Updated Product Bulletin

328 CHUCK SLIDE

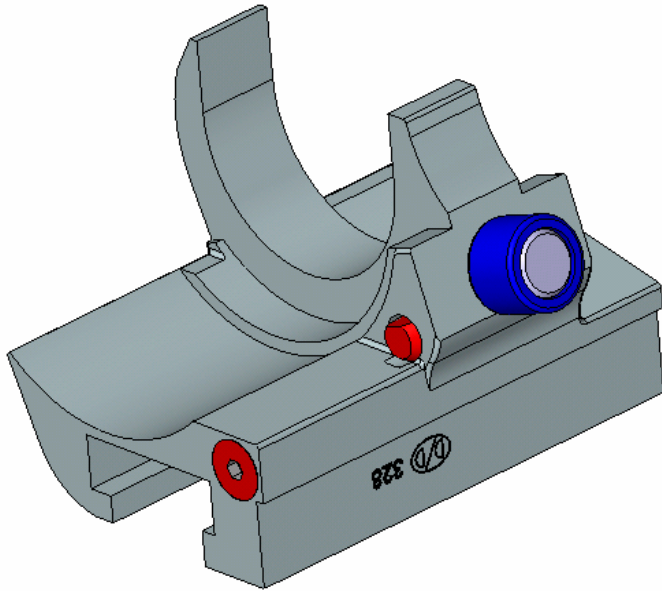
Davenport has enhanced this part, and now makes our chuck slides from new, high quality, investment castings, using a new bronze alloy. The new 328's have higher strength and wear resistance, so they last longer. In addition, we have added the innovative new *wear screw* on the front corner of the slides. This area was prone to being rounded off by pry-bars used to open collets during half-index. Now you'll never have to replace slides too early, or skin your knuckles when the pry bar slips off the worn corner. These features, combined with our new precision manufacturing process, ensure Davenport OEM 328 slides are an exceptional value.

- Made from high quality, investment casting.
- Stronger and more wear resistant bronze material.
- The new *wear screw* extends the useful life of the slide, and makes it safer too.
- Lower **long-term** cost-of-ownership with reduced repair/replacement costs.
- 100% interchangeability with genuine Davenport Machine OEM parts.
- Similar updates have been made to the 446-7 Feed Slide
